ASSISTANCE IN THE ESTABLISHMENT OF
A PESTICIDES PRODUCTION AND FORMULATION PLANT

SI/URT/86/875

Technical report: Construction of Chemical Plants*

Based on the work of Rajinder N. Juneja,
expert in construction of chemical plants

WELFARE BLOCK. CONSISTING (DISP. 40 M², CANTEN 115, C.C.M. MEETINGS/Common 72 M² & CHANGE 100 M²)
 TOTAL = 27230 X 12 = 327 M²

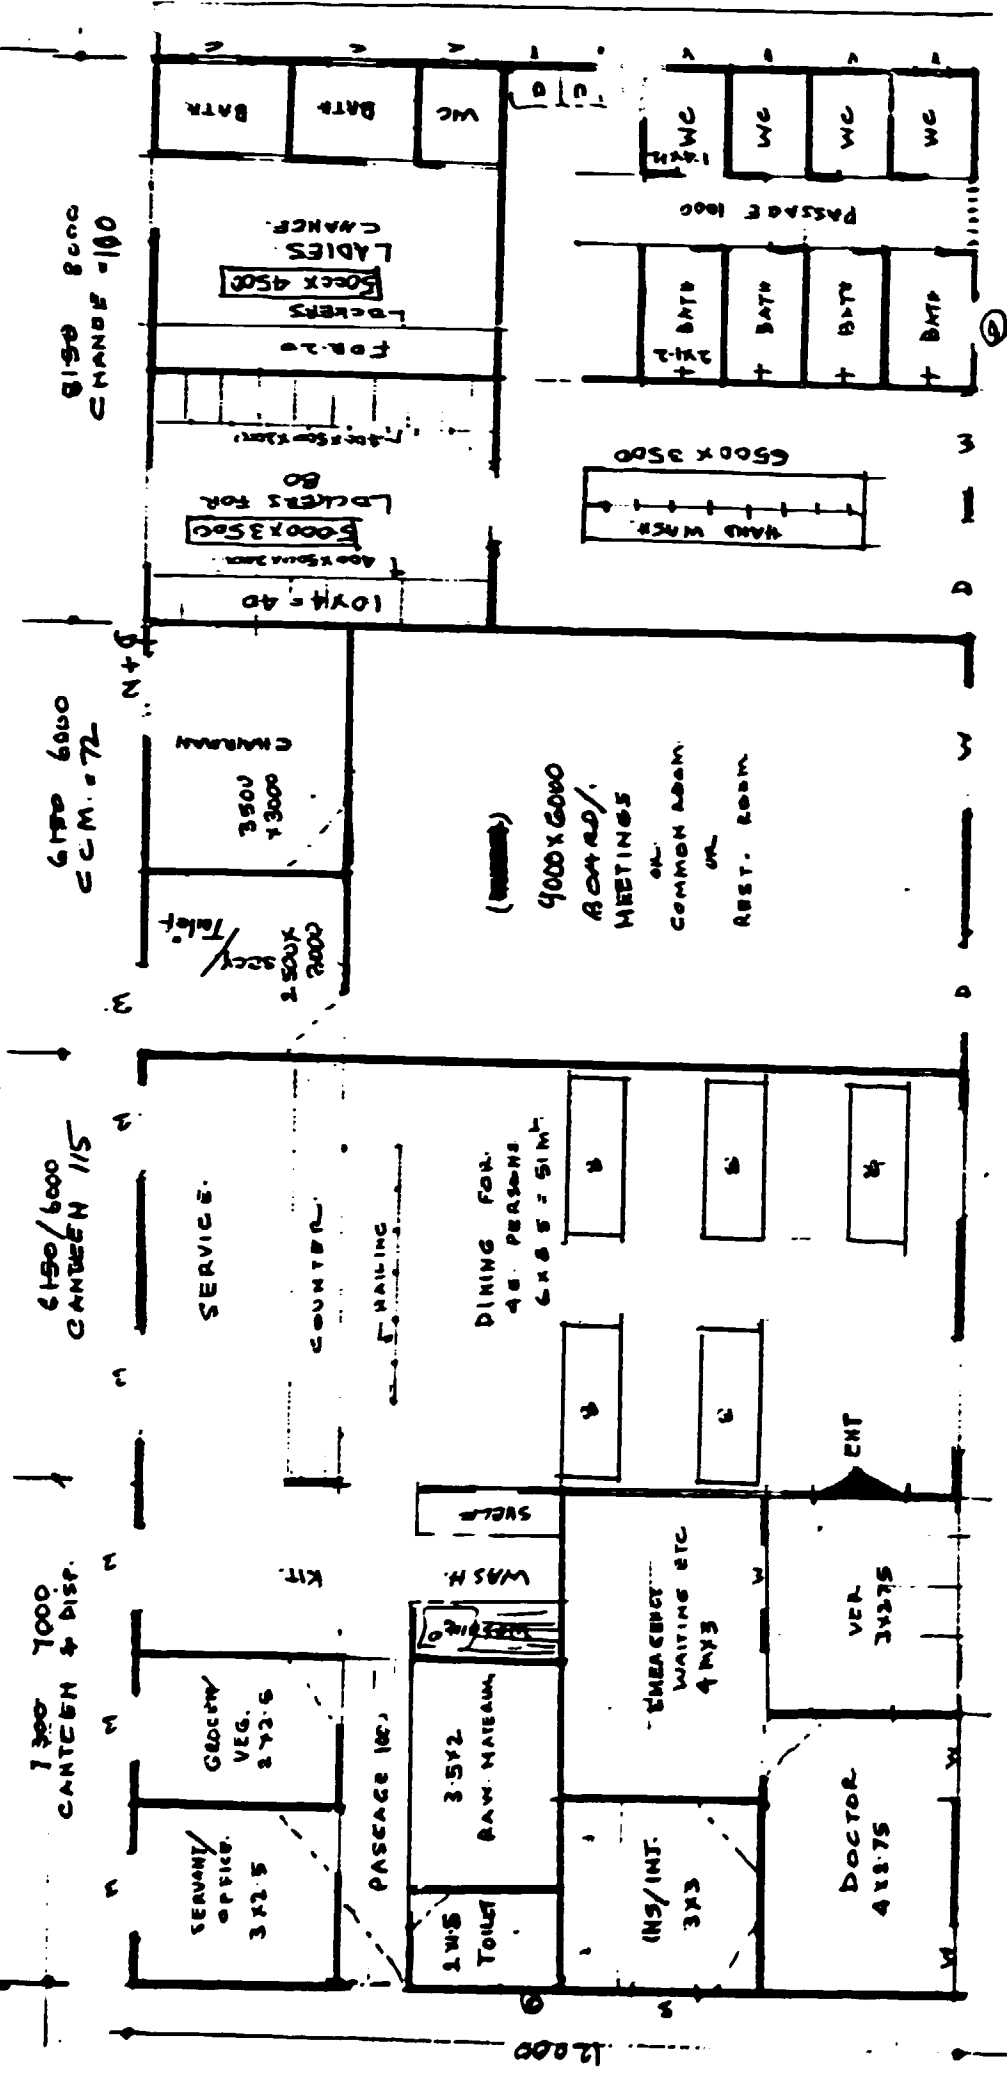
The Annexure V on manpower indicates, that maximum 81 employees would be present in the general shift. The general practice in the factories is to segregate the lunch timings. The paper mill at Moshi is observing two lunch timings for shift/office and General Staff and the canteen dining hall is enough for 100 employees to take food. Their total strength is between 350-375.

Keeping in view that the lunch timings would be staggered provision of 40 seats is enough.

The proposed factory is located in the vicinity of Moshi Town, which has got the facilities of General Hospital. Therefore a dispensary to provide 1st aid and emergency treatment has been proposed, which will have the provision of a Doctors Room, injection-cum inspection room and emergency and waiting having a covered area of app. 40 m². (Ref. Annexure VIII)

It is understood from consultants at Arusha, that provision of office space and meeting area for about 50 persons is an obligatory requirement. An area of 72 sq.m. has been proposed for this purpose and is indicated in the welfare block sketch at Annexure VIII.

The area of 115 m² has been provided for canteen in the sketch drawing attached at Annexure VIII.

100/125/150 ϕ PVC PIPE SLEEVE.

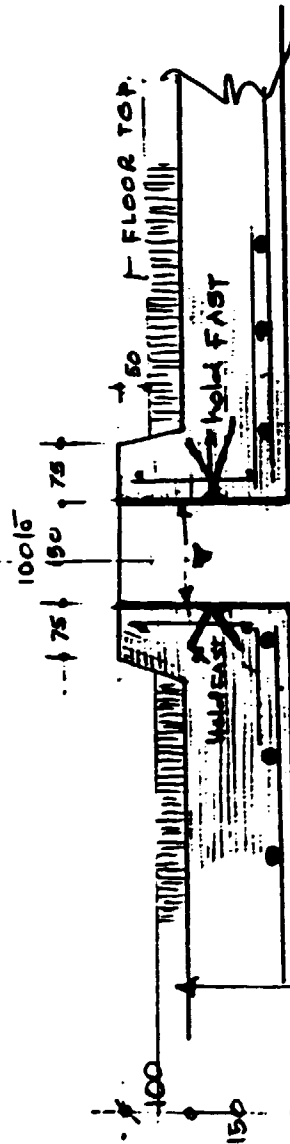
- Provision of Five escapes be made in both the buildings.
- Provision of steel girders with chain pulley blocks have been made over all the heavy equipments and vessels in both the buildings. These chain pulley blocks would only be required at the time of erection or maintenance and will get corroded if left hanging over the equipments. As an alternative it is recommended to provide holes of 100 to 150 dia in the R.C.C. slabs over the heavy equipments and chain pulley blocks could be installed as and when required. The details of this arrangement have been shown in Annexure IX.

R.C.C SLAB TO DESIGN. THE SLAB TO BE DESIGNED TO TAKE CARE OF THE LOAD OF LIFTING EQUIPMENT.

125/150 DIA HOLES OVER THE HEAVY EQUIPMENTS FOR ERECTION/LIFTING.
